PROJECT NAME: Civitas - CEPEO École Le Prélude Music Room Addition
ISSUED ONLY TO: CIVITAS GROUP.
ADDENDUM NUMBER: ~~#04~~ 01
ISSUE DATE: OCT. 23, 2018
ATTENTION: Douglas Rancier

Mechanical Addendum MA-01

Date	Oct. 17, 2018	Pages	3 (incl. this page)
To	Doug Rancier Civitas Architecture Inc.	From	Tom Armstrong, B.A., Mechanical Technologist
Client No.	-	Jp2g No.	2160398A
Project	Civitas – CEPEO École Le Prélude Music Room Addition

Project:
**ECOLE LE PRELUDE MUSIC ROOM
ADDITION**
6025 PROMENAGE LONGLEAF ORLEANS, ON

1 SKM-200.1 **GROUND FLOOR PLAN - FIRE PROTECTION LAYOUT - EXISTING SYSTEM**
SCALE: 1:50

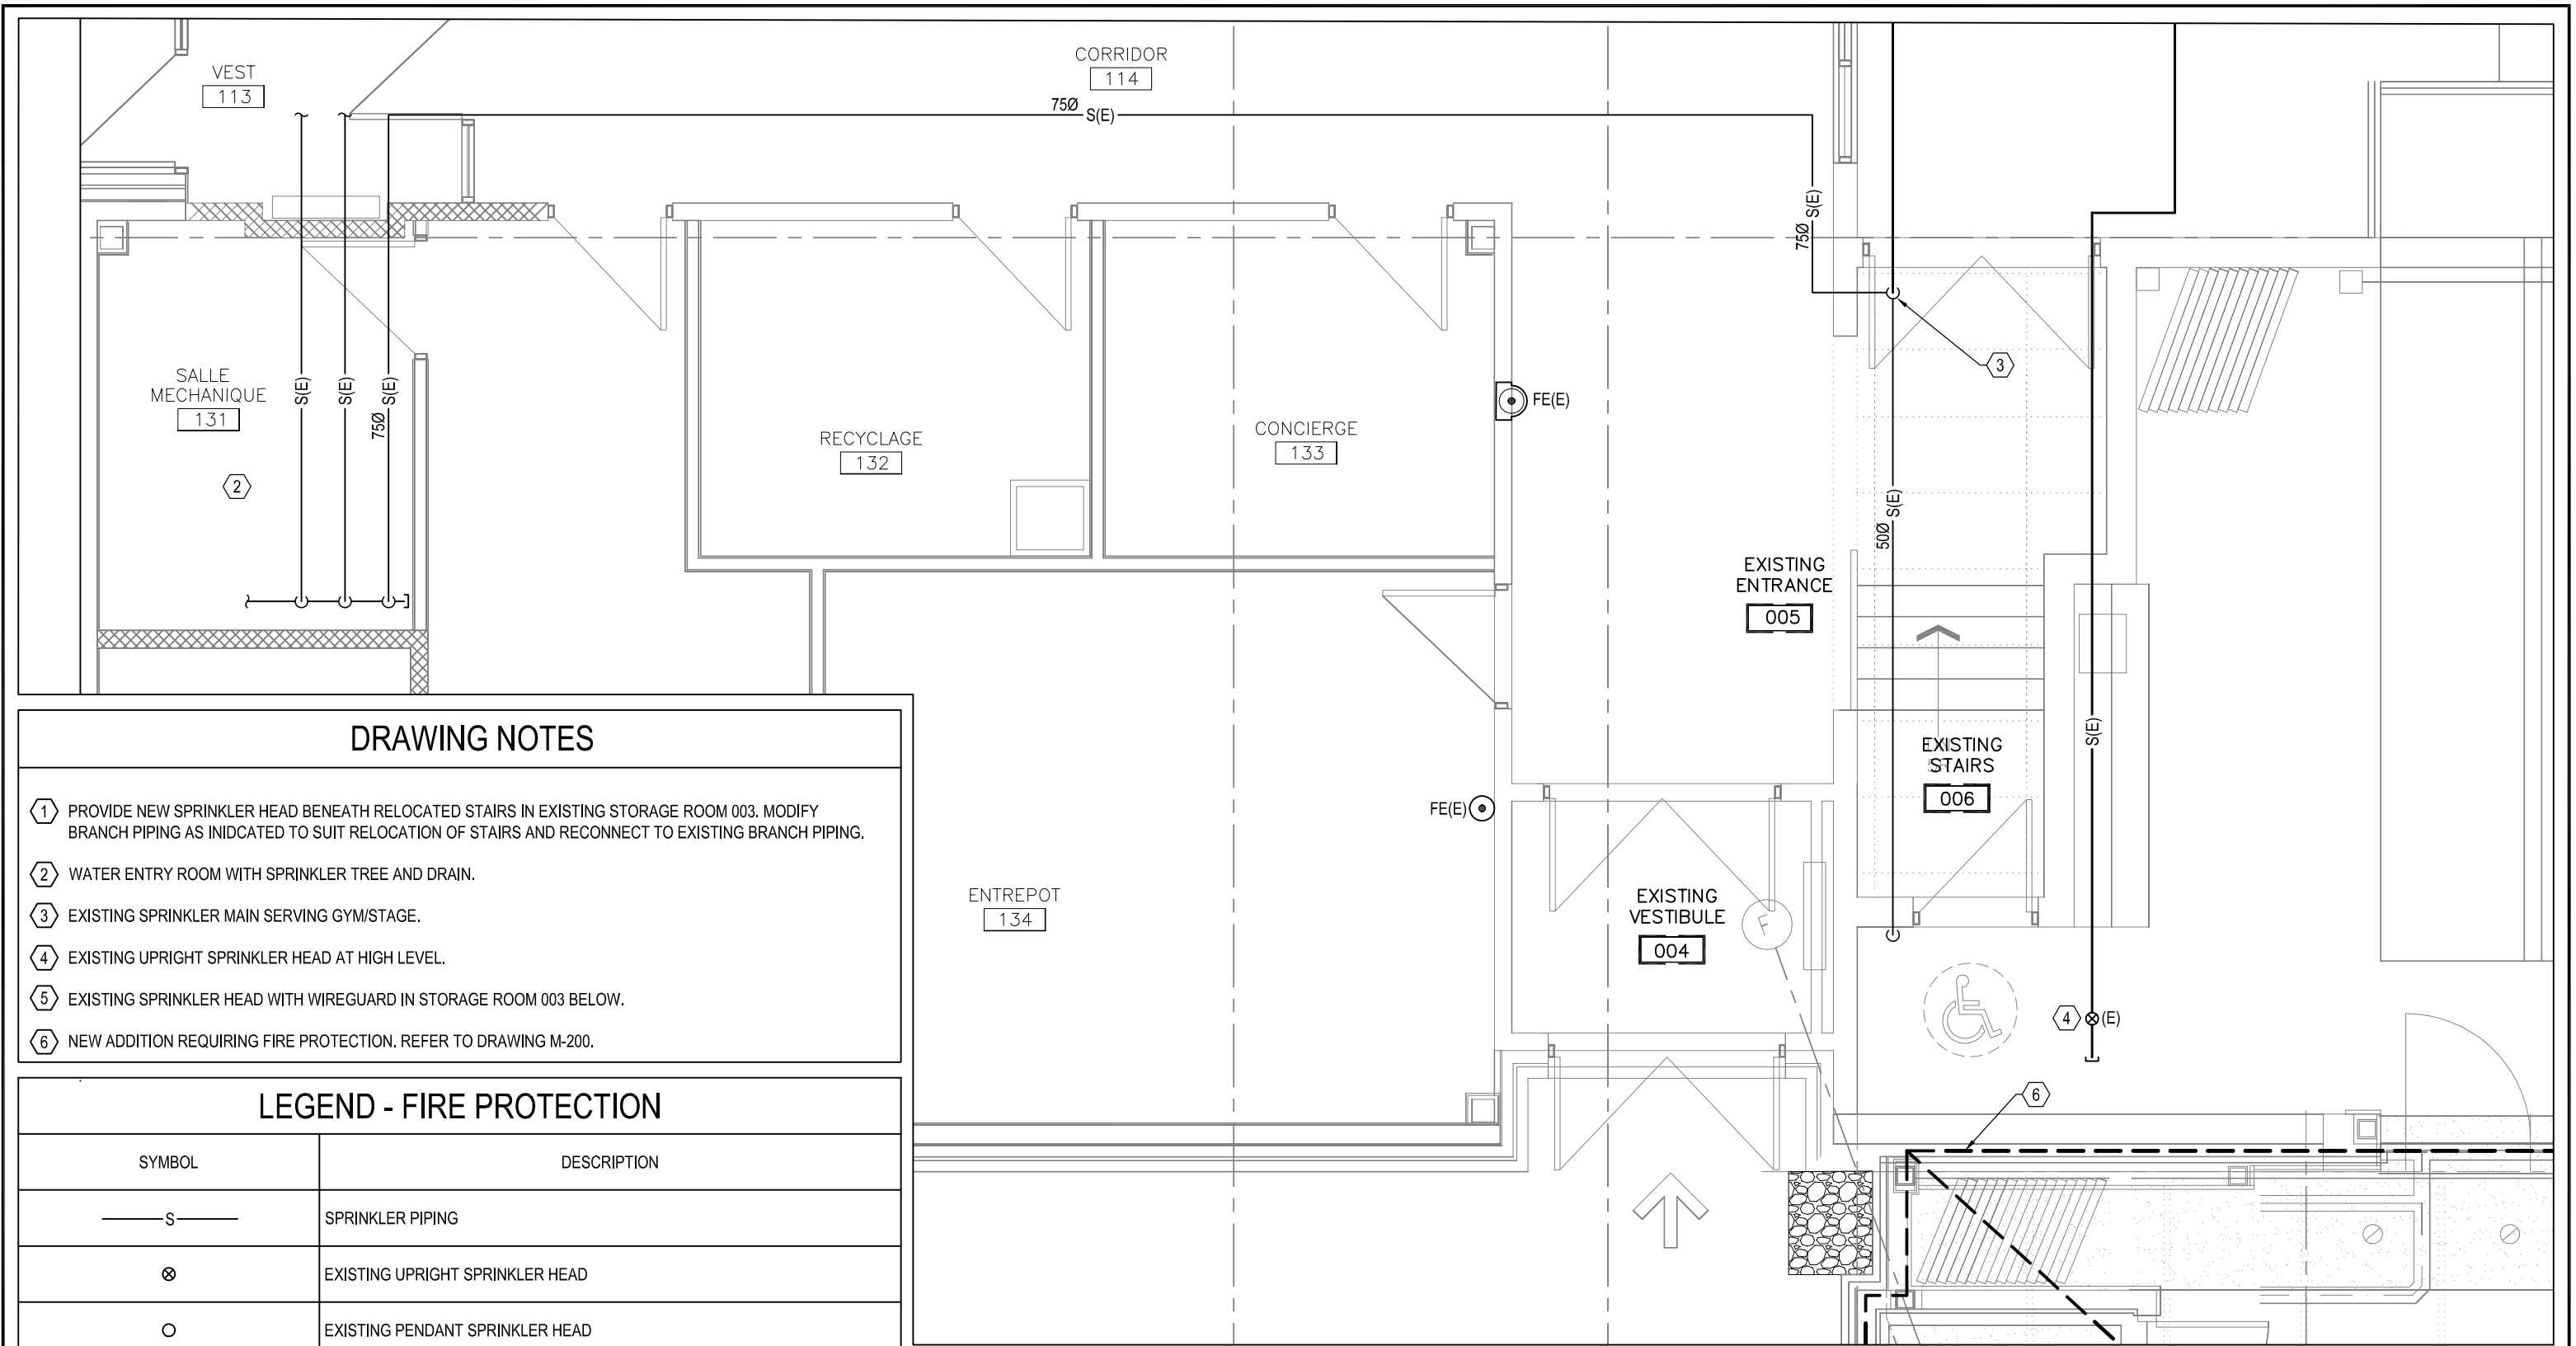
- .1 Include the information shown on SKM-200.1 and SKM-200.2 on drawing M-200

- ① PROVIDE NEW SPRINKLER HEAD BENEATH RELOCATED STAIRS IN EXISTING STORAGE ROOM 003. MODIFY BRANCH PIPING AS INDICATED TO SUIT RELOCATION OF STAIRS AND RECONNECT TO EXISTING BRANCH PIPING.
- ② WATER ENTRY ROOM WITH SPRINKLER TREE AND DRAIN.
- ③ EXISTING SPRINKLER MAIN SERVING GYM/STAGE.
- ④ EXISTING UPRIGHT SPRINKLER HEAD AT HIGH LEVEL.
- ⑤ EXISTING SPRINKLER HEAD WITH WIREGUARD IN STORAGE ROOM 003 BELOW.
- ⑥ NEW ADDITION REQUIRING FIRE PROTECTION. REFER TO DRAWING M-200.
